TRUCK, UTILITY, LIGHTWEIGHT, MC2 LANDROVER 110 - ALL TYPES

FUSING OF ADDITIONAL CIRCUITS

MODIFICATION INSTRUCTION

FIG 1 - TERMINAL ASSEMBLY

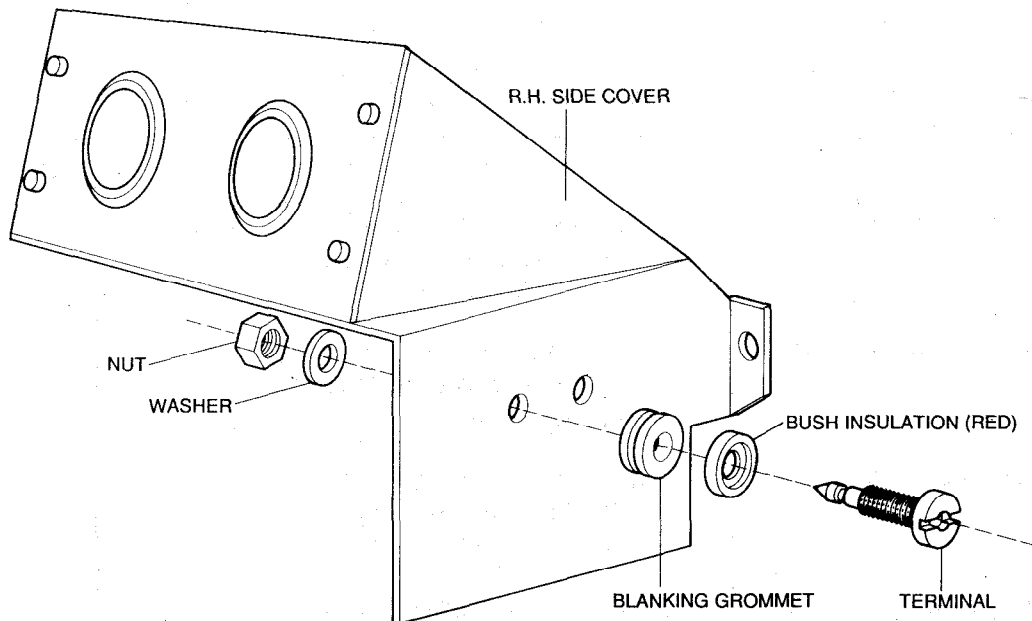
7. The modification is to be carried out as follows:
- a. Remove the passenger seat base and disconnect the battery.
  - b. Unscrew and remove the instrument dimmer switch cover panel (cargo) or upper instrument panel (FFR).
  - c. Inspect the dimmer switch for serviceability and ensure that the wiring has been modified in accordance with EMEI VEH G 197-3.
  - d. Disconnect the brown wire to the positive (red) inspection light socket.
  - e. On FFR variants:
    - (1) Undo the positive terminal securing nut and remove the terminal;
    - (2) Fit the grommet (item 1 from Table 2) to the terminal access hole and push the terminal through the centre of the blanking grommet; and
    - (3) Reassemble the terminal as shown in Fig 1.

FIG 2 - FUSE COVER

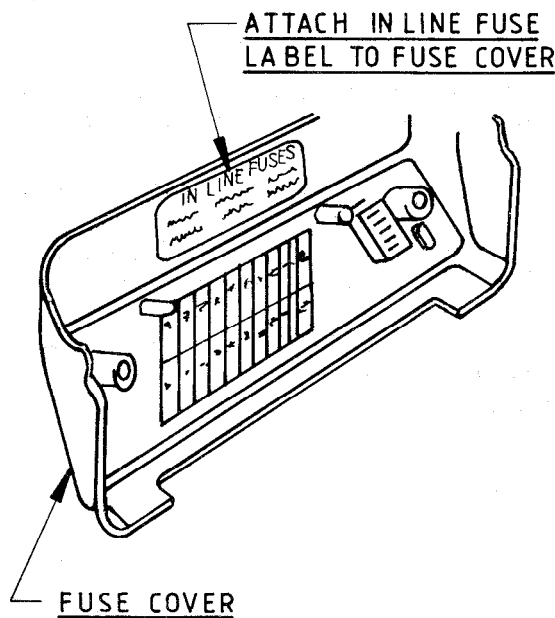
- g. Remove the white cable that connects the dimmer switch to the main harness and replace it with the 5 amp fused cable link (item 4 from Table 1).
- h. Interlock the fuse holders with a cable tie (item 2 from Table 2).
- i. Attach the label (item 5 from Table 1) to the inside surface of the fuse cover as shown in Fig 2.
- j. Identify the brown wire with white ident, in the vicinity of the blackout switch, and ensure that the crimped connector on the wire is serviceable and fits securely into the connector on the brown/white wire.

FIG 3 - FFR LAMP

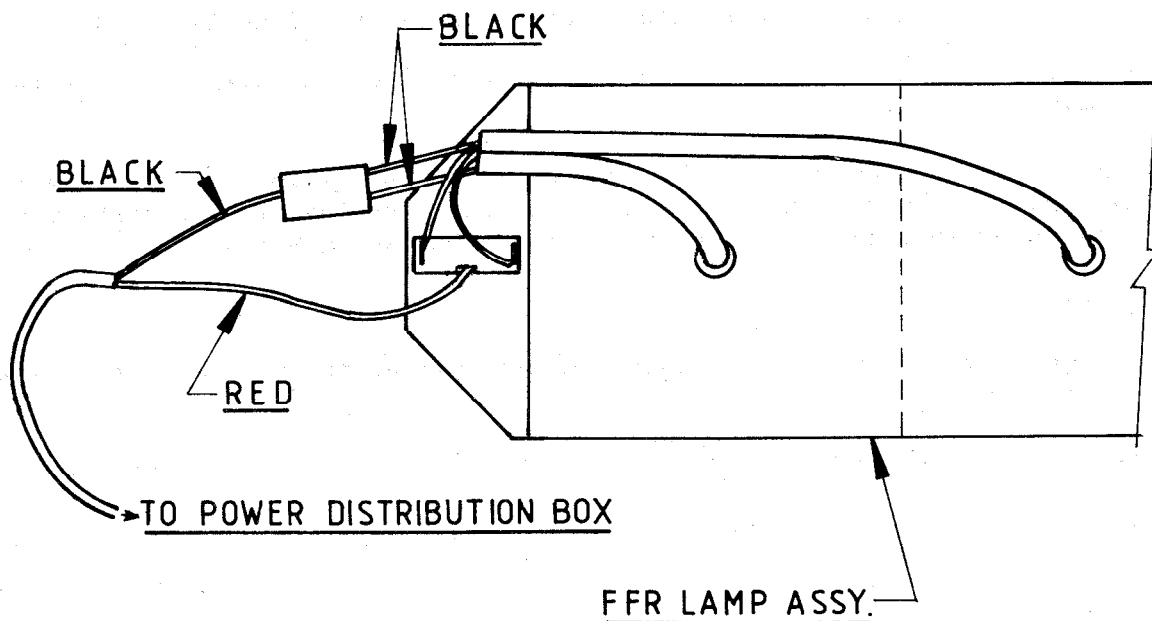
- l. Reconnect the battery and check that the inspection socket and instrument dimmer switch function correctly.
- m. Refit the passenger seat base.
- n. On FFR variants:
  - (1) Disconnect the radio batteries.
  - (2) Identify the red wire, as shown in Fig 3, cut it near the FFR lamp and fit the fuse holder and crimp terminals (item 6 from Table 1) to the wire.

(3) Fit a 5 amp fuse (item 7 from Table 1) to the holder and attach the holder to the loom with a cable tie (item 2 from Table 2).
